STATE	PROJ. NO.	FISCAL YEAR	SHEET NO.	TOTAL SHEETS
HAW.	B-3267-02-64	1964	2	13

TYPICAL SECTIONS
AND
STANDARD DETAILS
KAILUA-KAWAIHAE ROAD
PROJECT No. B-3267-02-64
Scales: As Noted
Sept. 1964

CATTLE GUARD DETAILS
Scale: as noted

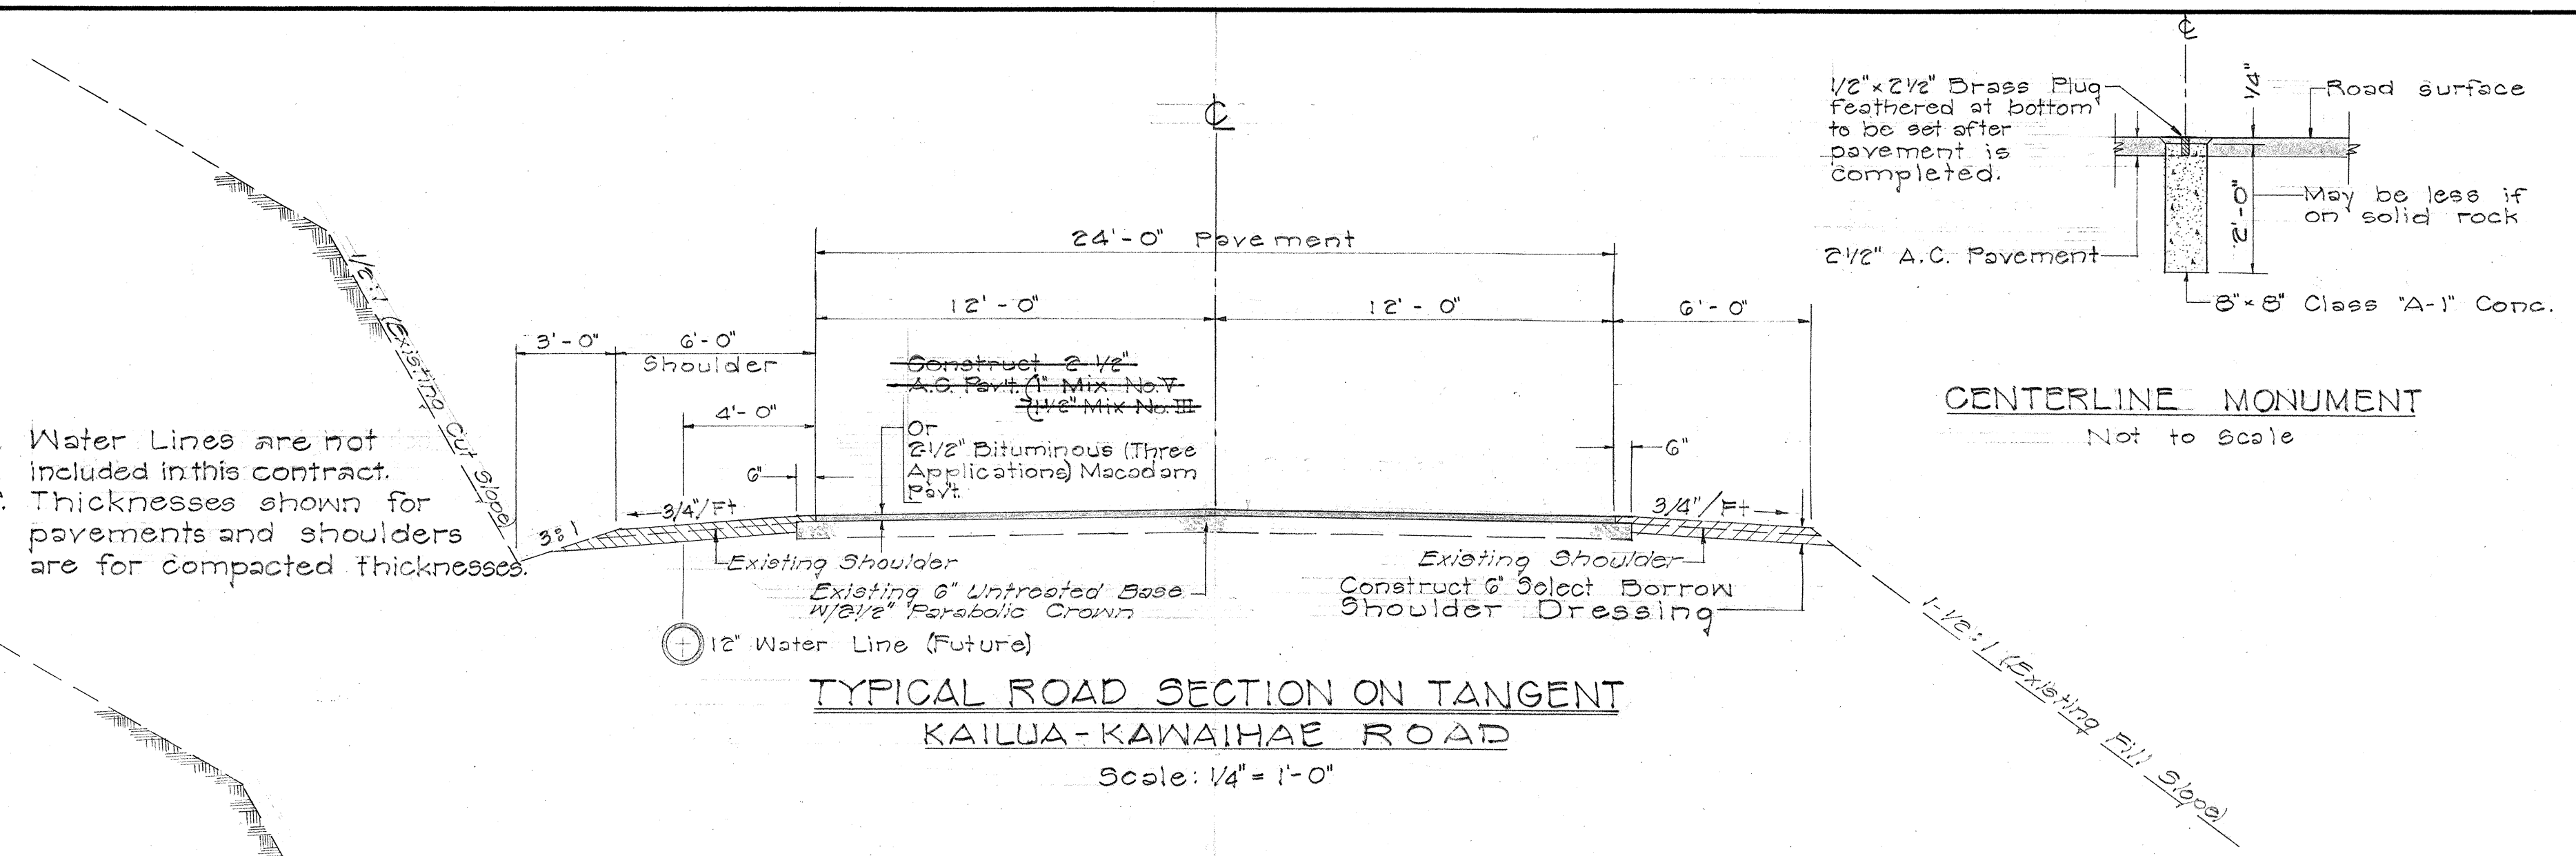
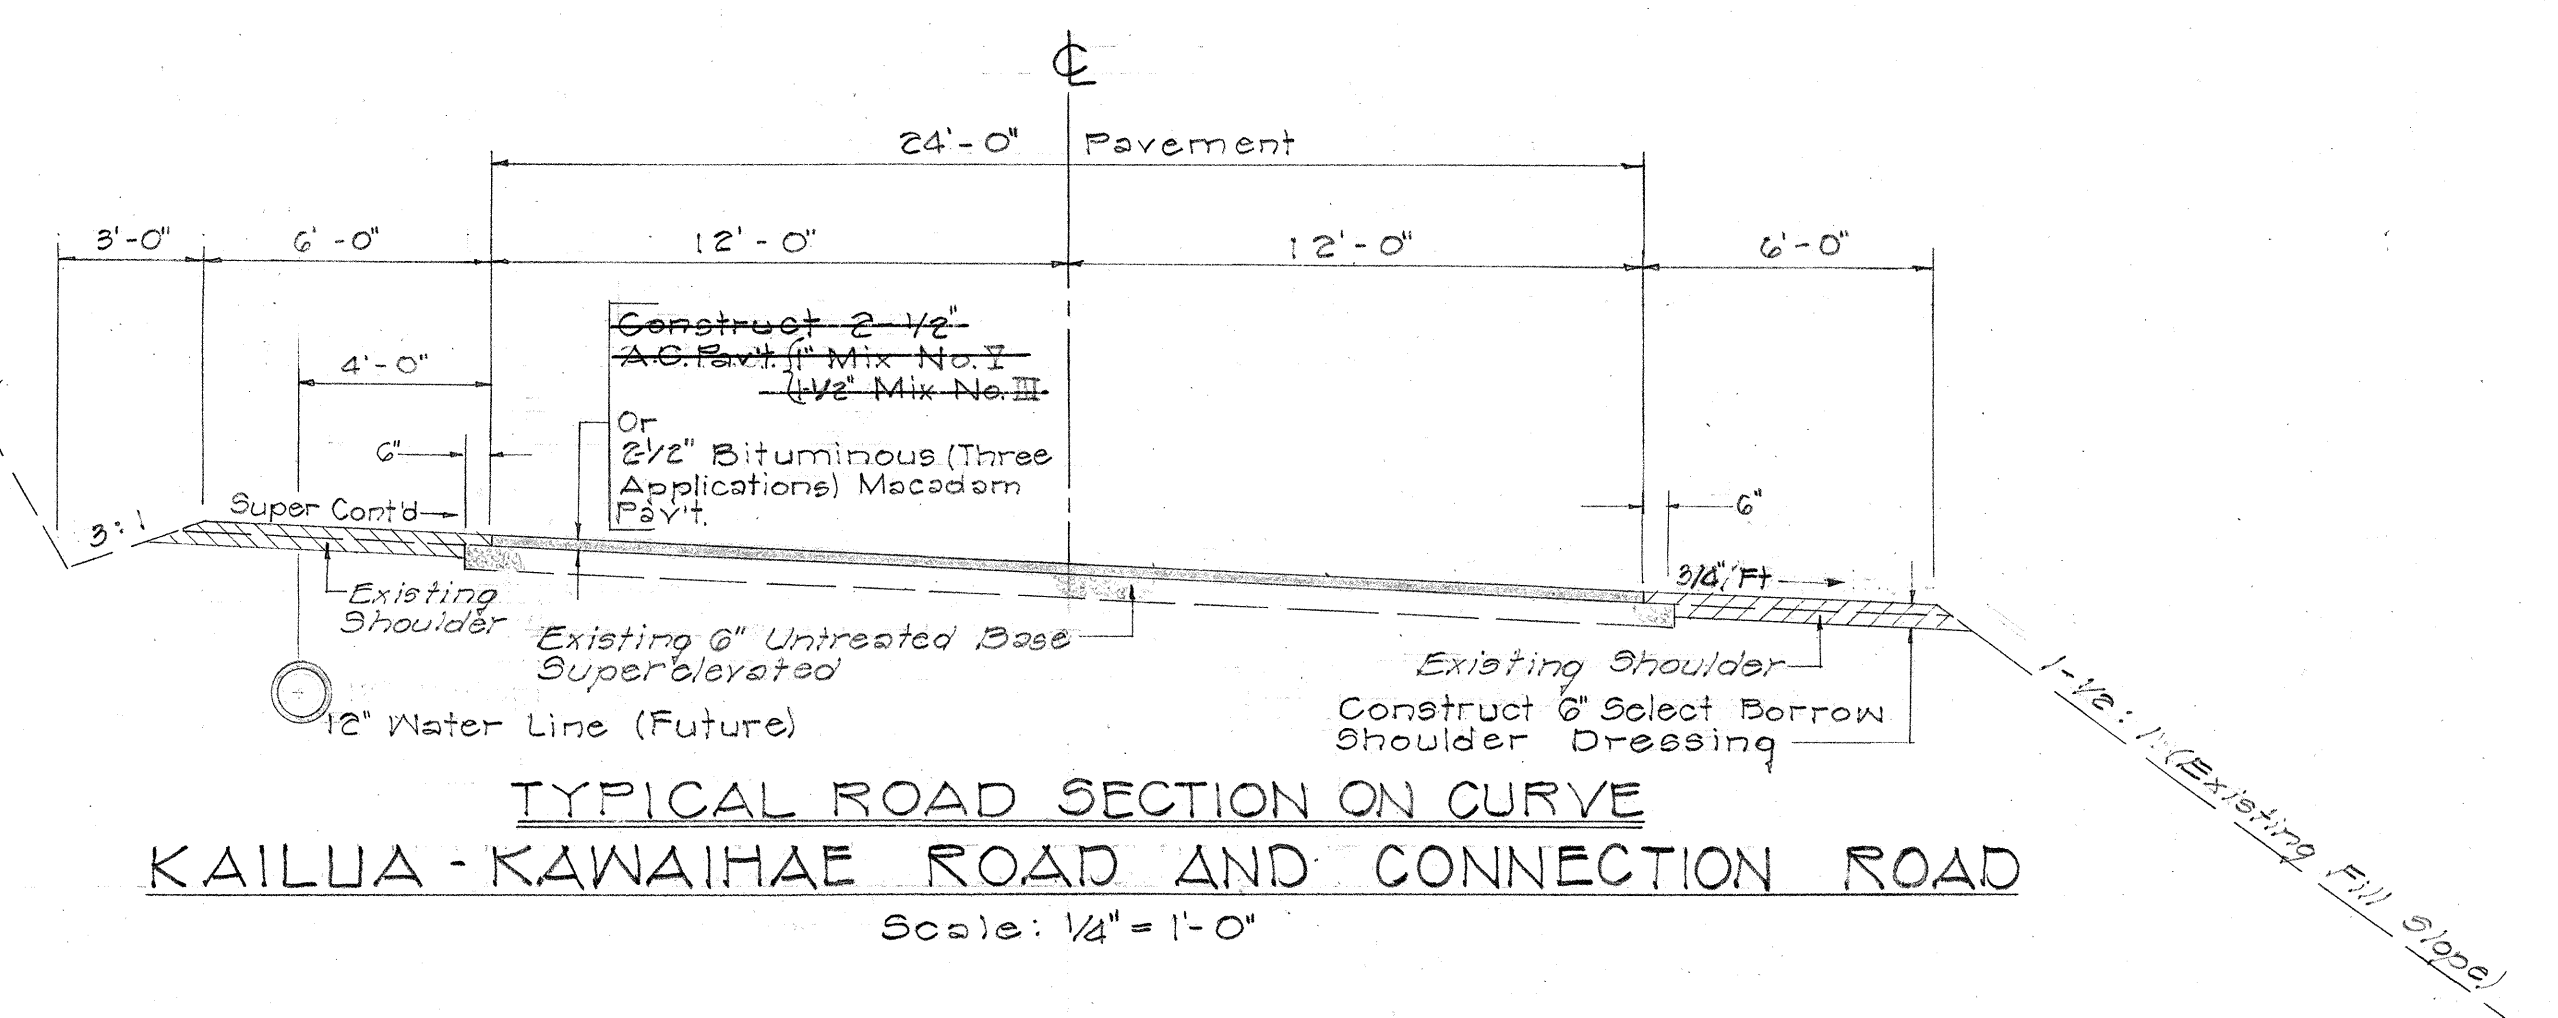
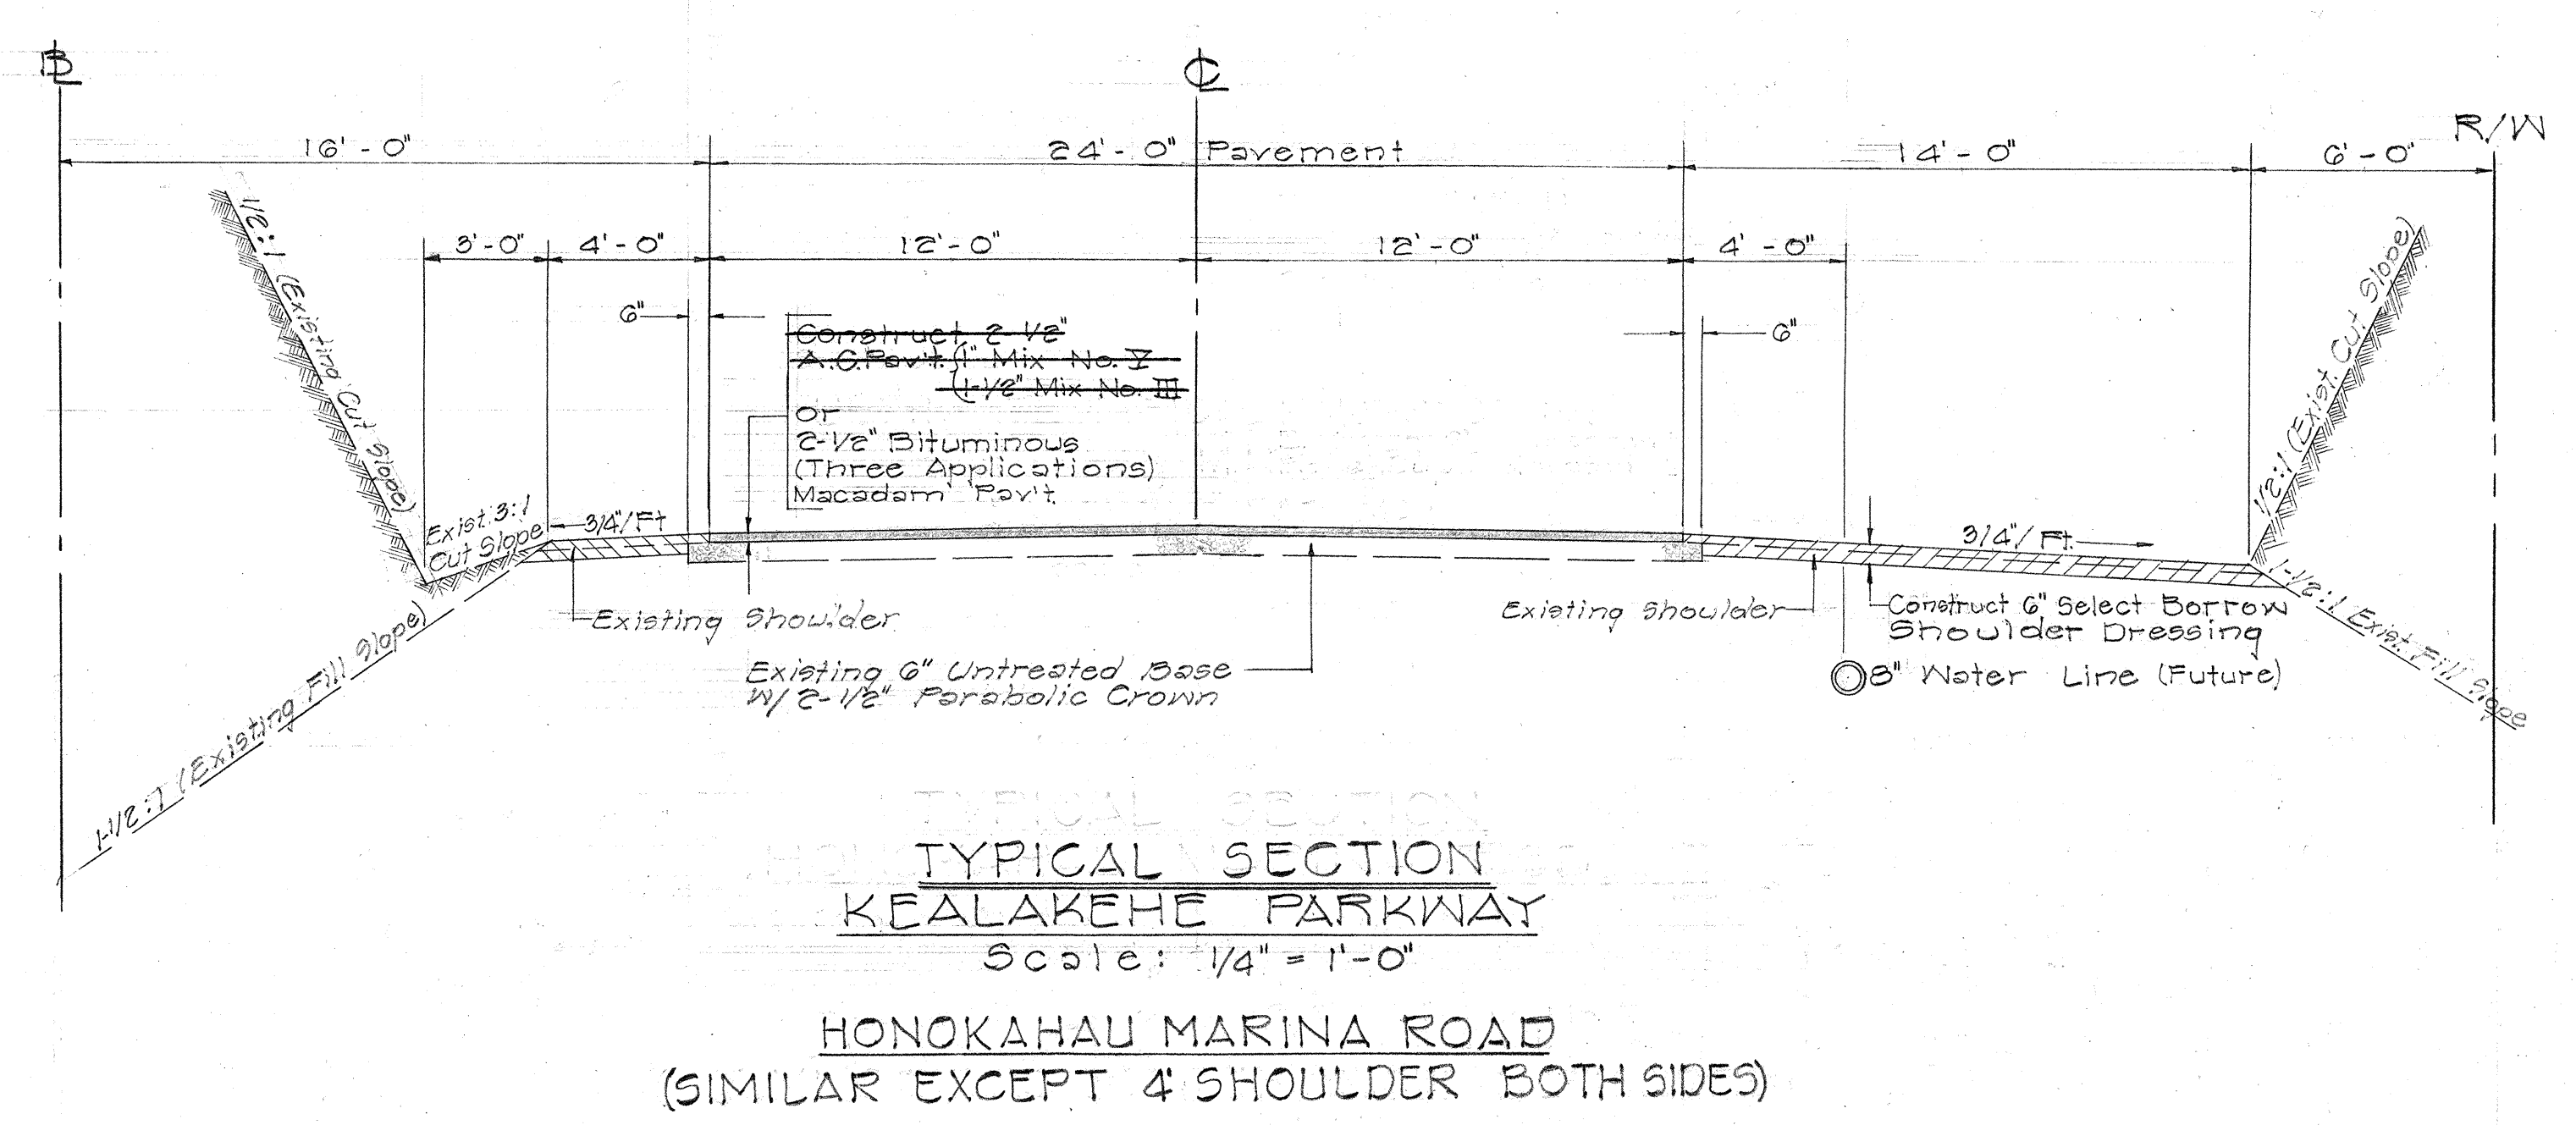
NOTE: Cattle Guard at Sta. 3+70 includes:
(Under Change Order No. 2, Feb. 5, 1965)
1. 50 lb. Rails in lieu of 60 lb. Rails.
2. Two Additional 10-I-25.4 Steel Beams and One Additional Rail.
